Field Cage V3

CONCLUSIONS FROM CAGLI

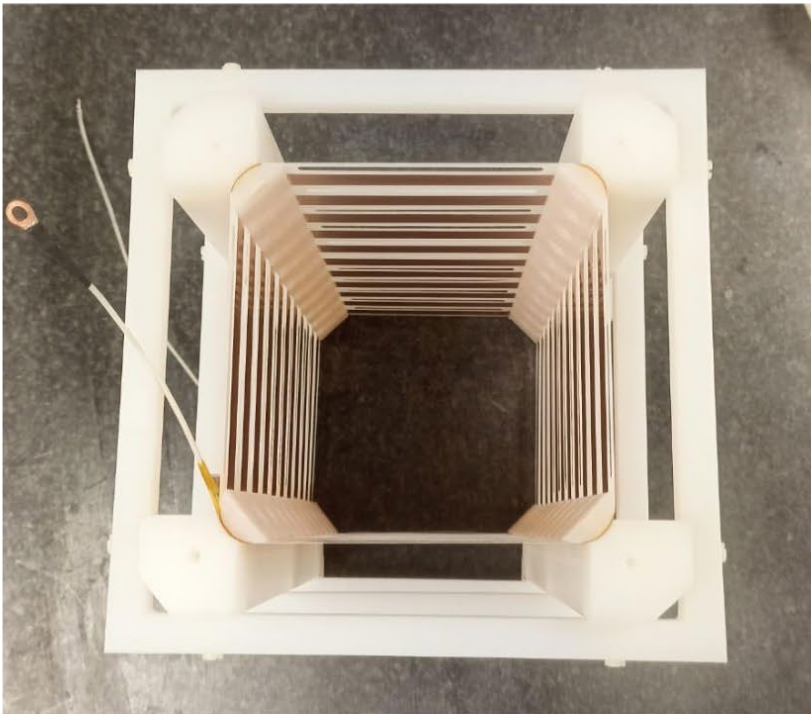
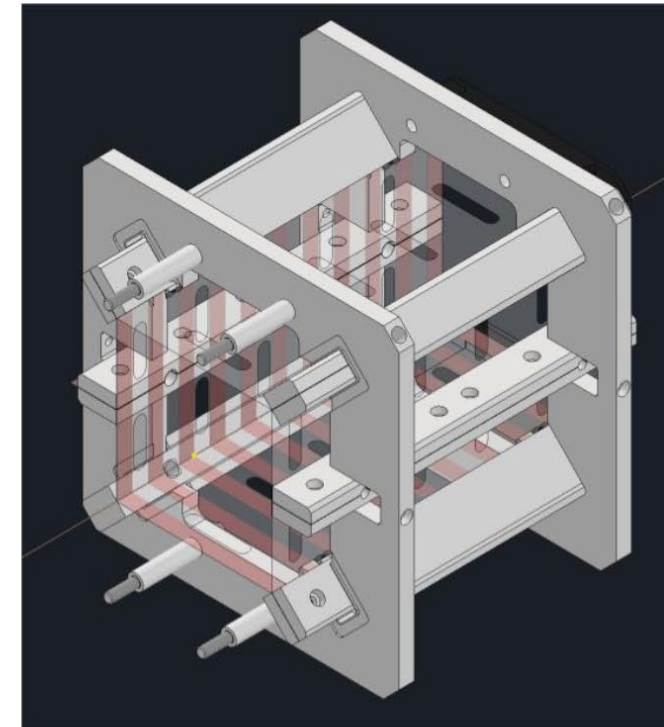
- Next step is to try a hybrid between the two FC
- Using the material and resistor position of of the FC_V2_1, but the clipping angles of FC_V2_0 to try to guarantee better corners and solidify the hypothesis of the deformation

Va sviluppato un modello ibrido di FC e risolto il problema di interferenza con il telaio delle GEM.

About source ports on the copper shielding and PMMA

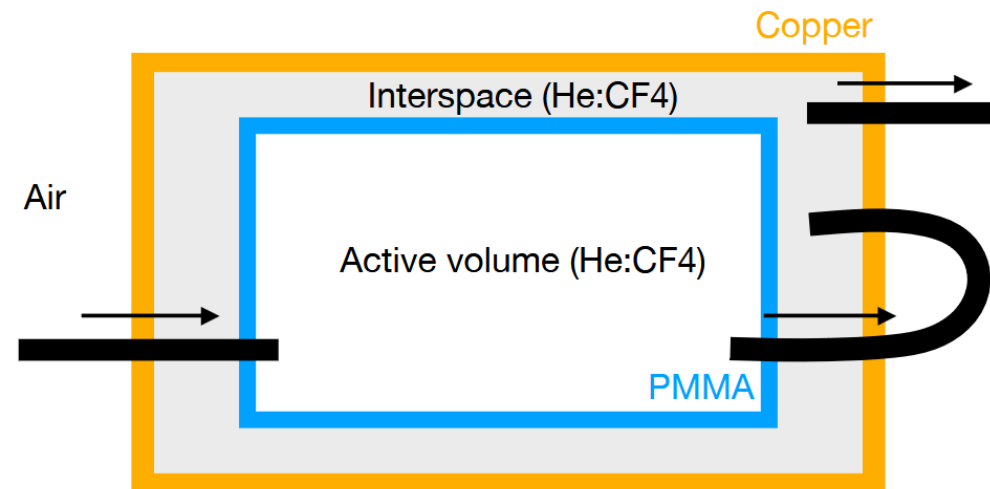
For the Ru source, we should foresee a inlet to inject the Kr in the gas;

For the ^{55}Fe , our proposal is to have:

On the COPPER

- 14 slits 62.5 mm apart each other;
- 4.5 x 14.5 mm² and 40 mm deep (the whole clean copper layer)

On the `PMMA

- 2 windows (1 per half volume)
- 80 x 402 mm² windows

This setup should allow 10 kHz of events (about 2 Hz/cm²)

Port for source on neutron shielding

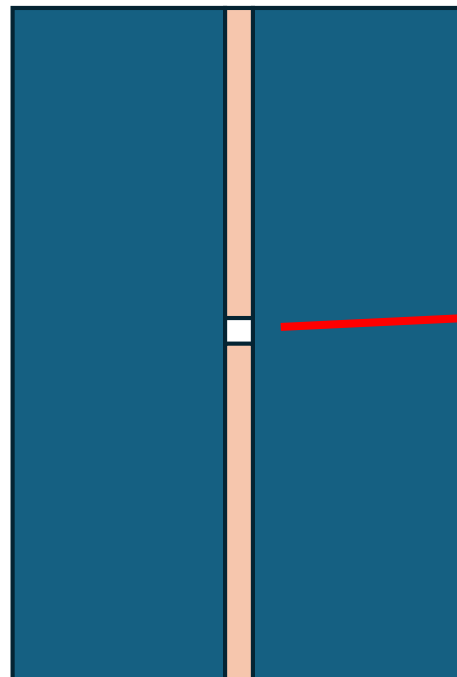
It is needed a port, see real dimensions on source (Roberto), on the neutron shielding (tanks). This port should be located in the middle of the cathode.

We can use a PE plate with a hole...

Ask Roberto the real
dimensions of the
source
